GUAM POWER AUTHORITY

AMENDMENT NO.: I

INVITATION FOR MULTI-STEP BID NO.: GPA-034-18

BUILD, OPERATE & TRANSFER CONTRACT FOR 180MW OF NEW GENERATION CAPACITY STEP 2 – TECHNICAL SPECIFICATIONS

Table 12.1: Procurement and Development Milestones

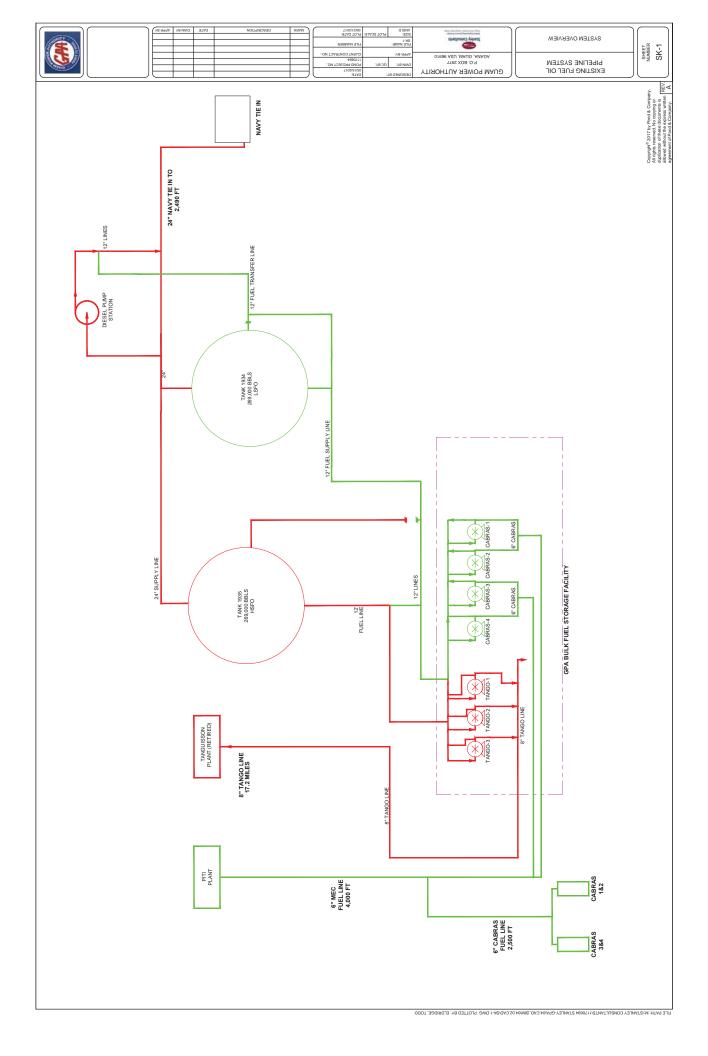
Kindly *REMOVE* pages 28 and 29 of 595 pages and *REPLACE* with 28a and 29a of 595 page. Changes are necessary to reflect Procurement and Development Milestone to only page 29a.

New Generation Infrastructure Lot 5010-1New&5042-R1&5042-1 **Guam Power Authority**

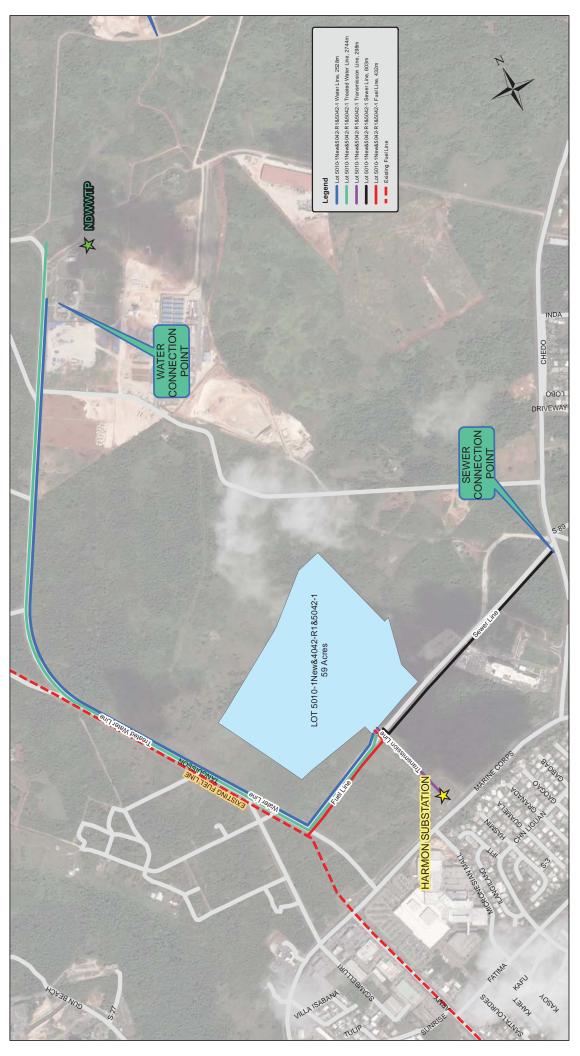
5. Can GPA provide to bidders a map of the project area that shows GPA's property line, the plant site, the desired transmission line route, the Harmon substation, and the proposed access roads?

The plant site and the desired transmission line route are shown in the map provided in the pdf attachment - New Generation Infrastructure Lot 5010-1New&5042-R1&5042-1_V2.pdf. The map provided shows the access road that runs from Marine Corp Drive to Highway 34.
